**EVALUATION OF LYDIAN AMULSAR GOLD
MINING PROJECT:
ASSESSMENT OF ARD POTENTIAL AND EFFECTS
ON SURFACE WATER AND GROUNDWATER**

17TH JUNE 2017

Prepared by: Andrea Gerson
Roger Smart
Blue Minerals Consultancy

Figure 6-1 Total S (wt.%) versus sulfide S (wt.%) for Tig/Art waste rock (from Figure A1-2; GRE, 2014).

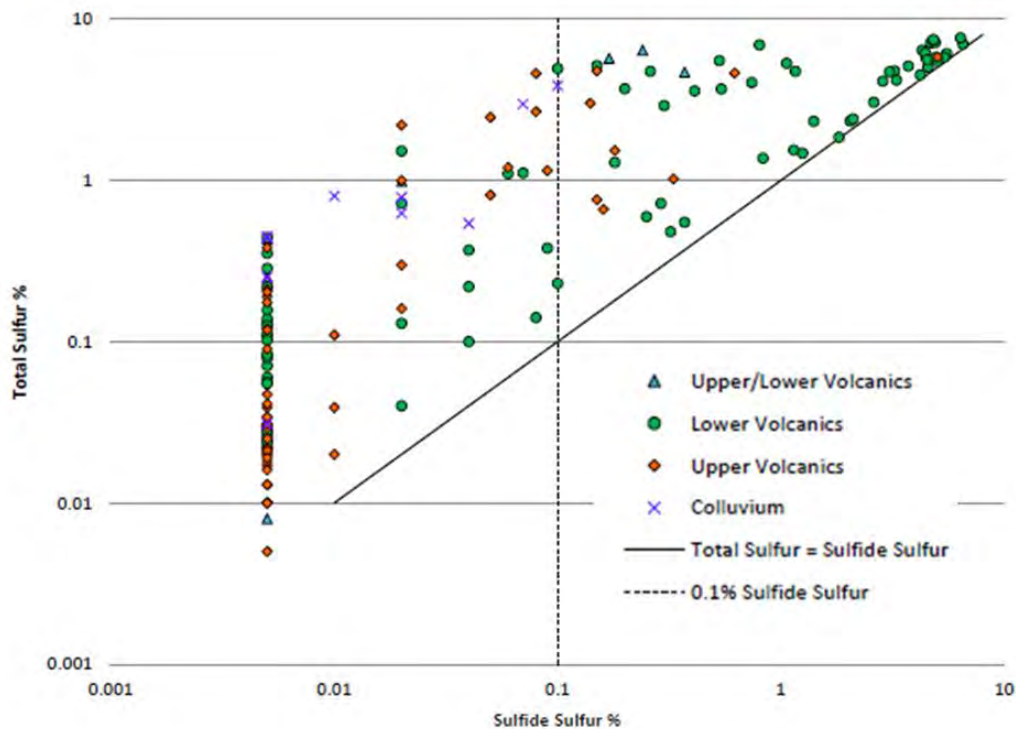
Figure 6-1). This would equate to 2–19 wt.% pyrite. In fact, the greatest concentration of sulfidic S in the LV samples is 6.52 wt.% (sample ARD-2, Appendix Table A-1, GRE, 2014) equating to 12.2 wt.% pyrite. In all these samples, serious ARD would be predicted by international standards.

Figure 6-2 Histogram of wt.% sulfide S in LV and UV Tig/Art samples.

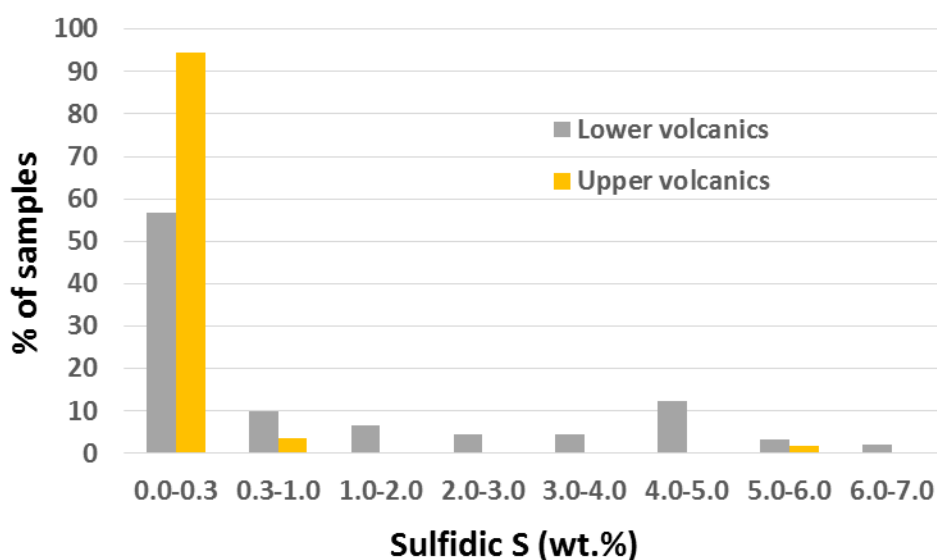
However, in our histogram (Figure 6-2) distribution (compiled from data provided in GRE, 2016 Appendix Table A-1) of sulfide S wt.%, it is found that more than 50% of the samples contained less than 0.3 wt.% – generally considered a conservative cut-off below which the risk of ARD is not considered to be significant. This suggests that this material could be used as NPAG cover material.

In the UV samples greater than 90 % of the sample contain less than 0.3 wt.% sulfide.

Figure 6-5 pH versus time in humidity cell tests (Figure 8-1, GRE 2014; Figure 5, Appendix 8.19 ESIA 2016).

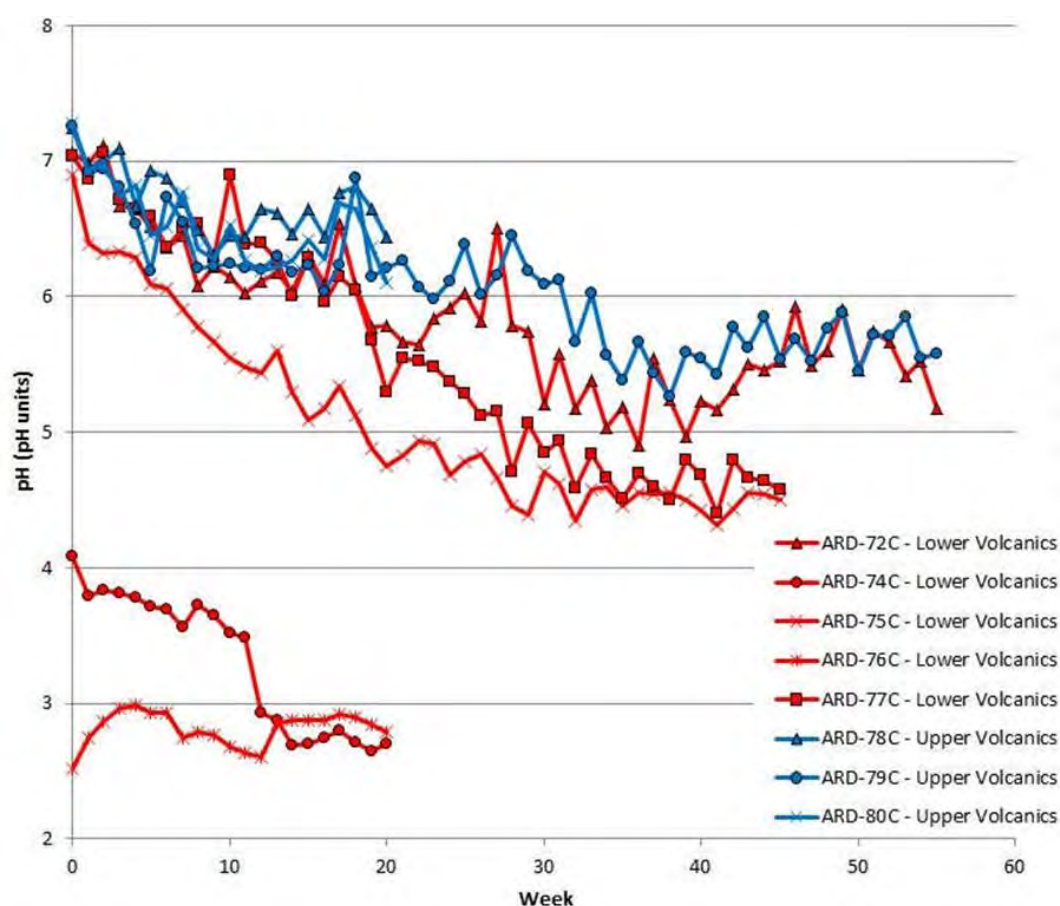
“...three of the five LV kinetic cells showed strong resistance to the formation of ferric iron oxidized ARD. These samples produce consistently mild (pH greater than 4.5) ARD, with low sulfate, nearly zero cumulative acidity, and low iron concentrations despite long-duration testing.” (page 38, GRE 2014).

These were 72C, 75C and 77C. These contain 0.8, 0.2 and 0.3 wt.% pyrite sulfur. Hence their leach behavior reflects their pyrite content and not any unusual geochemical resistance.

Figure 7-1 ARD management (operations phase) plan (from Figure 8, Appendix 8.19, ESIA, 2016).

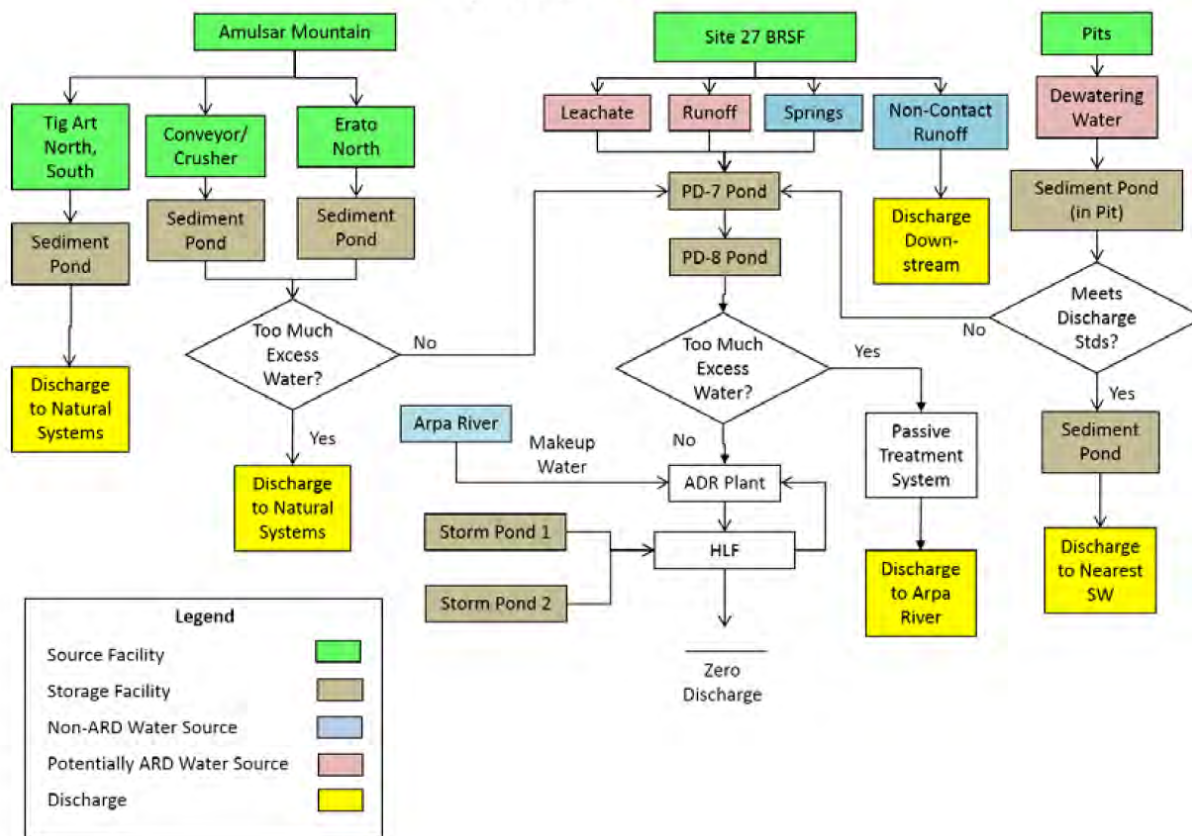
Pit backfill ARD mitigation is entirely inadequate and one of the most serious ARD problems worldwide. There is an unfounded, untested assertion on soil cover limiting oxygen penetration. There is also a clear statement that ARD will be released to seeps, springs and groundwater discharging down Amulsar Mountain. No effective treatment is planned (see Figure 7-1).

Figure 7-2 Encapsulation concept with low grade stockpile (from Figure 9, Appendix 8.19, ESIA, 2016).

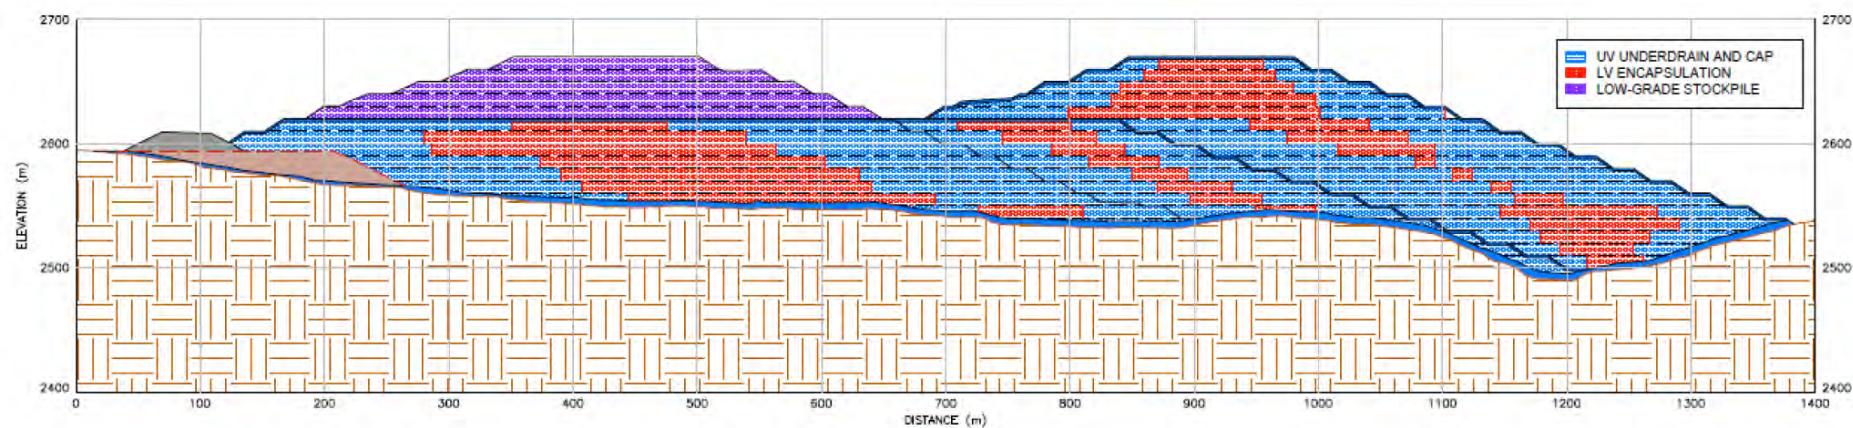
Figure 7-2, however, appears to show exposure of LV at the surface of the down-grade stockpile but this may represent progressive formation. More importantly the geochemical assessments of the Upper Volcanics in these documents is given as being uncertain to potentially acid generating. There is no NAG, non-acid generating, material.

This has not been adequately tested in the inadequate suite of humidity cells or any long-term tests. It is not the conclusion of their own categorisation of Uncertain to PAG (potentially acid generating) not NAG (non-acid generating) and suggests that Upper Volcanic encapsulation material is at risk of producing acid on weathering.

Figure 7-3 Close-up, moisture content distribution, year 8 (from Figure 10, Appendix 8.19, ESIA, 2016).

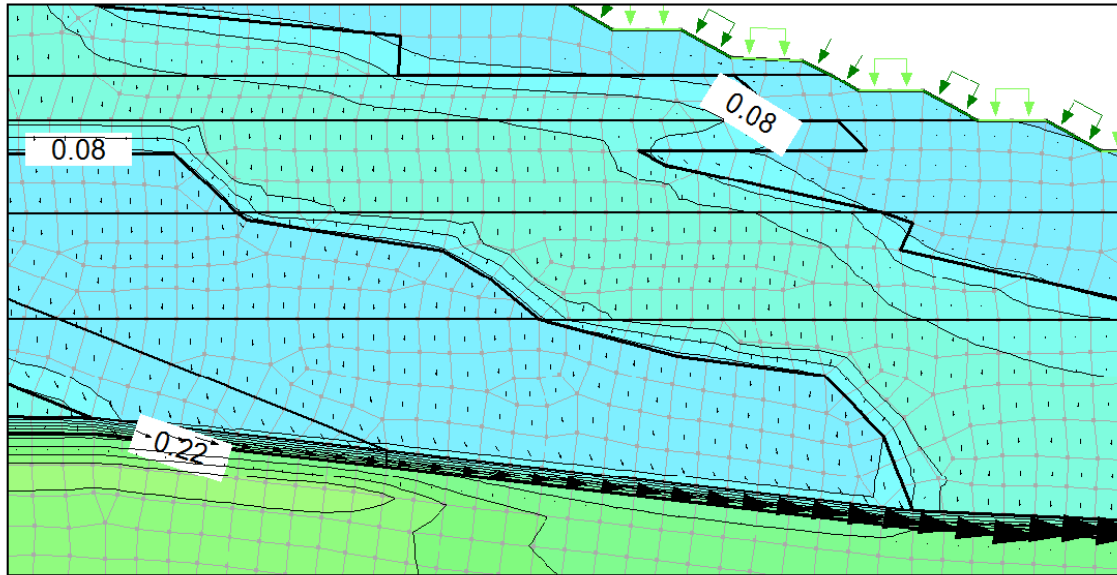
Figure 7-3) shows that the encapsulation is effective and that water should flow around and under the PAG material. Predicted flow within the PAG itself is low with the capillary action of the clay in the PAG helping to contain the ARD. **Nevertheless, the PAG seepage averages 33% percent of the total flow in the BRSF underdrain (**

Figure 7-4) so that the full estimation of the ARD characteristics of this PAG seepage are critical to the subsequent treatment.

Figure 7-6 Closure-phase ARD management plan (from Figure 13, Appendix 8.19, ESIA, 2016).

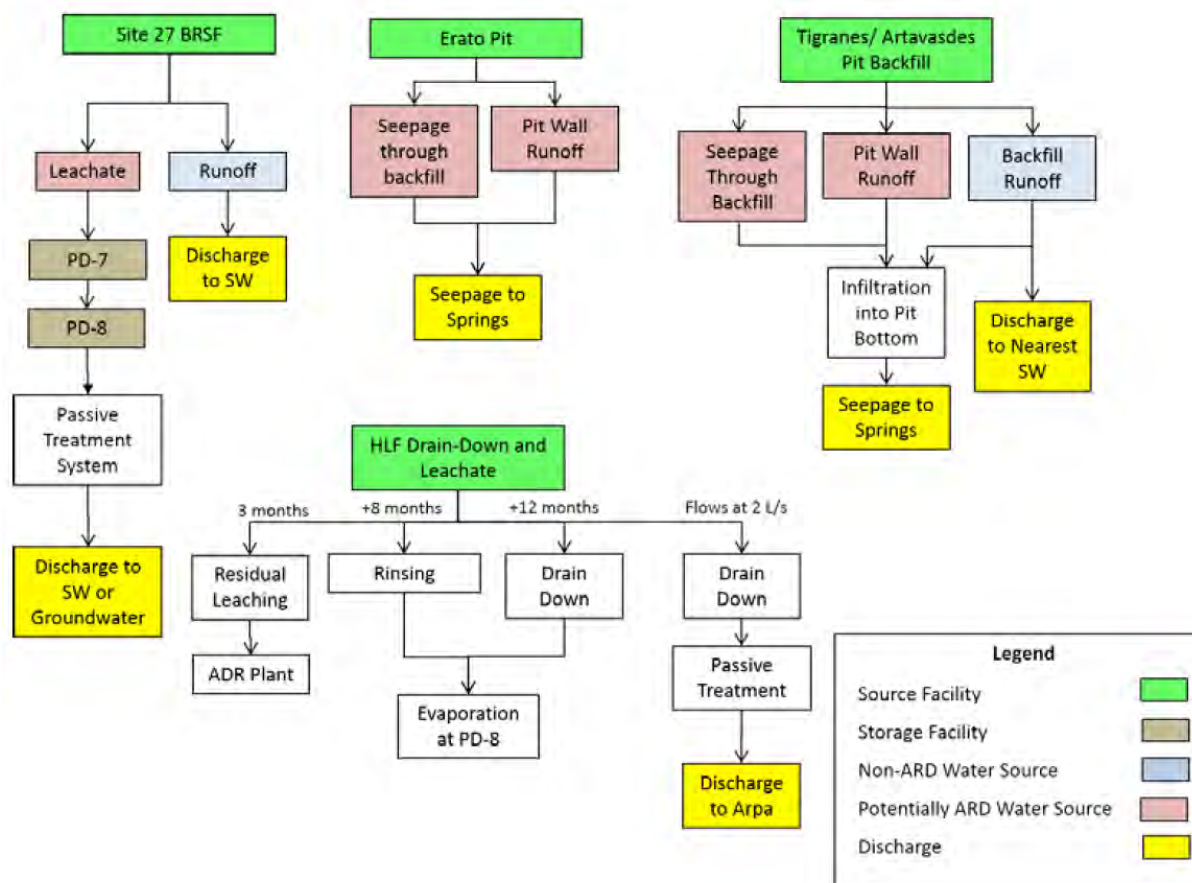
This closure phase plan confirms that, while the combined BSRF and Site 27 discharge will be treated in the passive treatment system, untreated discharges from the Erato Pit and two Tig/Art pits will be released to springs (

Figure 7-7 Closure phase ARD seepage from Tig/Art pits (from Figure 14, Appendix 8.19, ESIA, 2016).

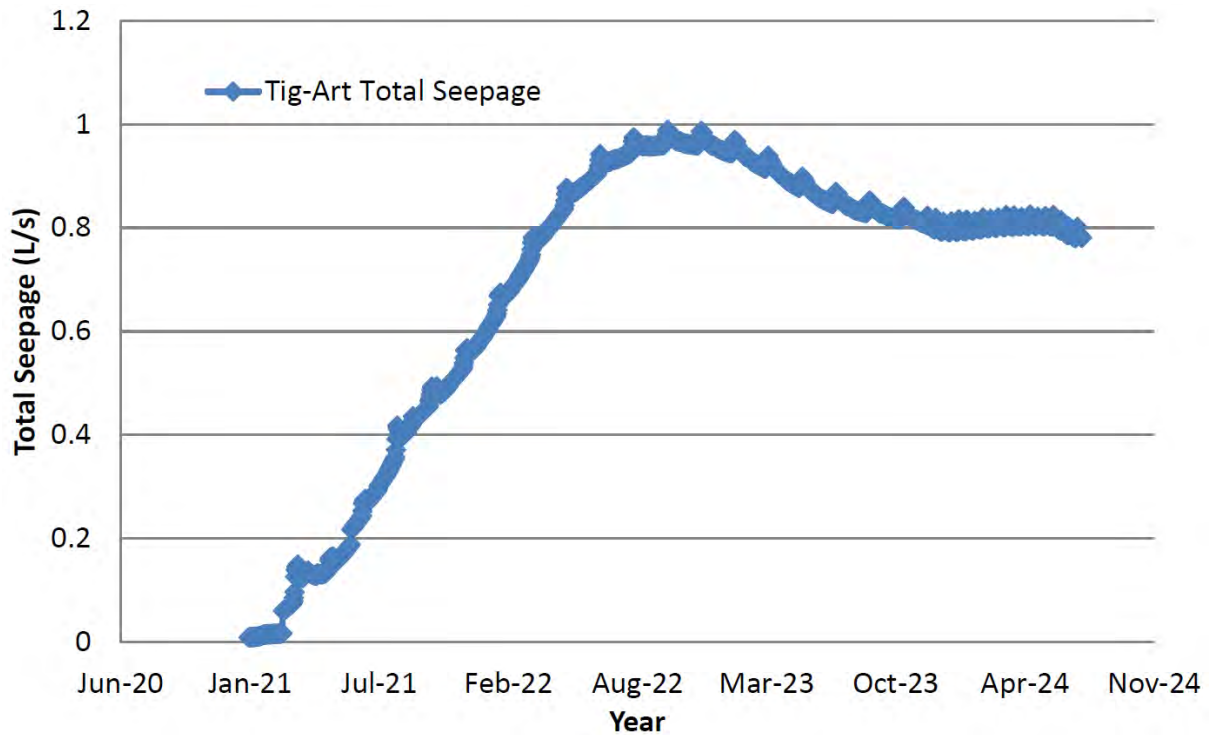
Figure 7-7 shows the total discharge (0.8-1.0 L/s) from each pit to the aquifer. The naturally occurring ARD (not defined) in seeps and springs on Amulsar Mountain is used to justify release of much more ARD to the same water flows. This is not reasonable or acceptable practice.

Figure 8-3 Groundwater flow pathlines post closure (from Figure 6.9.3, Section 6.9, ESIA, 2016).

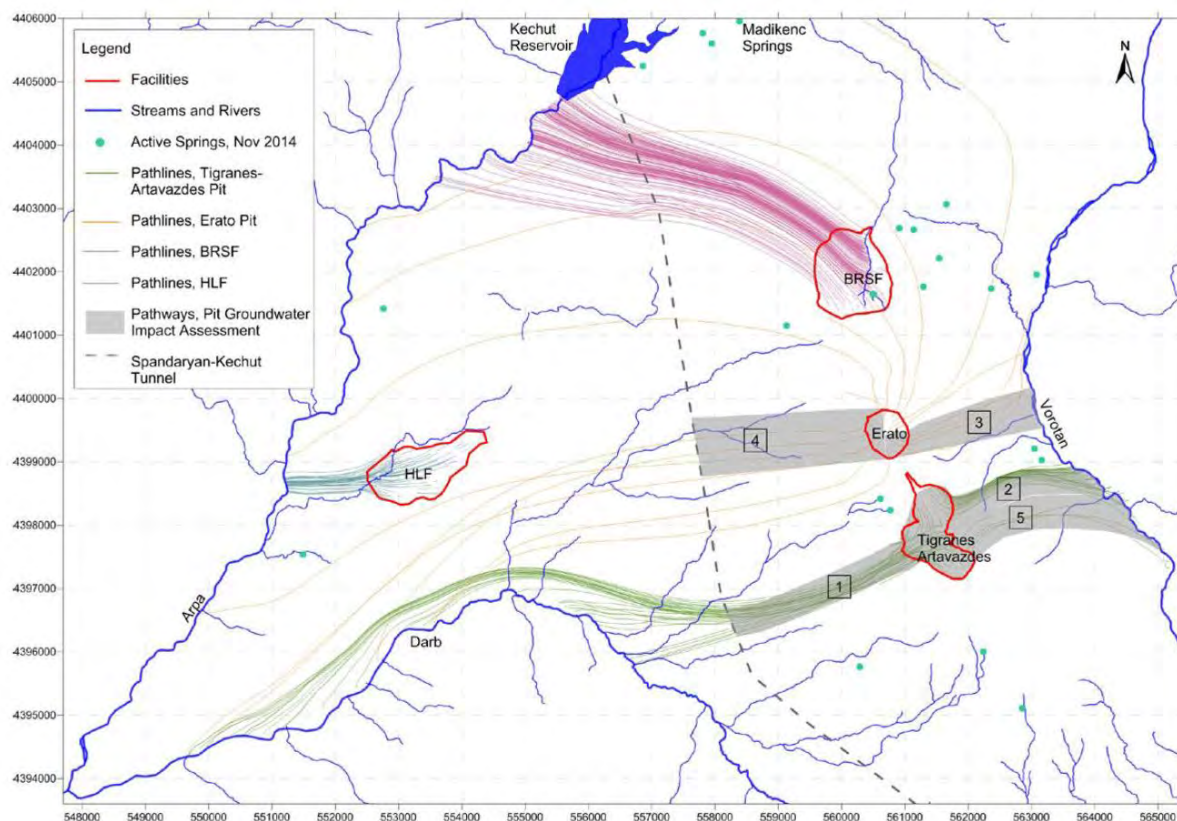
We are not expert in hydrogeological modelling but many of the changes (marked in extracts) in groundwater levels (e.g. 60 m lower), redirection and reduction in springs and streams predicted within and around the mine site, both in operation and after closure, appear to be of considerable magnitude. They are likely to impact any bore water being used in the region. They may concern the local communities and local governments.
